PLANNING & ZONING BOARD - CITY OF WILDWOOD
Special Magistrate – Lindsay C.T. Holt

Agenda
Regular Meeting
August 5, 2025 2:15 PM
City Hall Commission Chamber
100 N Main Street

**2. A25-0583 UF Health Oxford Freestanding Emergency Department
Portion of Parcel D17-134**

**PLANNING & ZONING BOARD OF THE CITY OF WILDWOOD
EXECUTIVE SUMMARY**

SHEET NO. C1.1

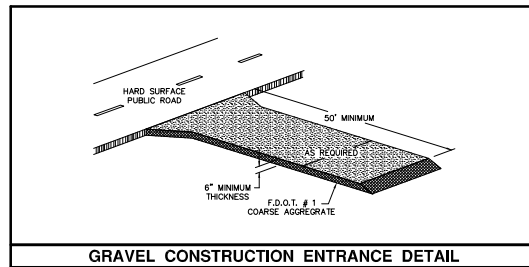
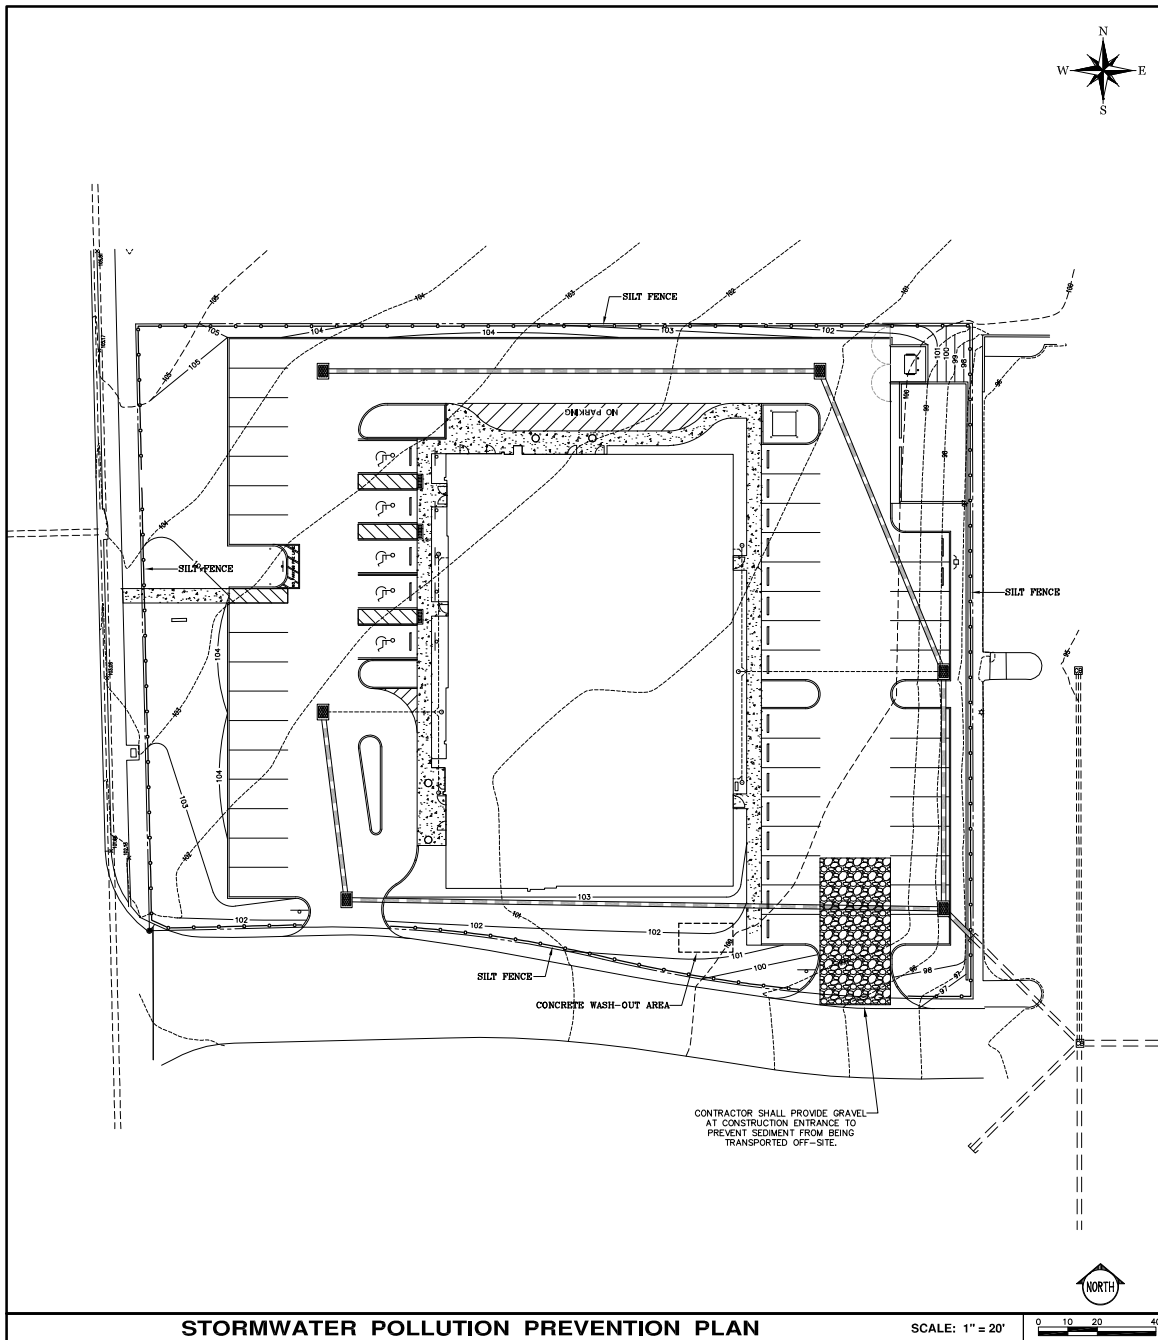
1. Please add the applicant's phone number to the cover sheet of the site plan.
 - A. The Applicant's phone number has been added to the cover sheet.
 - I. Not satisfied; the applicant information was updated, but the phone number was not included.

- a. **Applicant phone number added to Sheet C1.1.**
 - i. **Satisfied.**
2. Please provide an authorized agent form from the owner to the applicant (Boldt c/o Faeq Hussain).
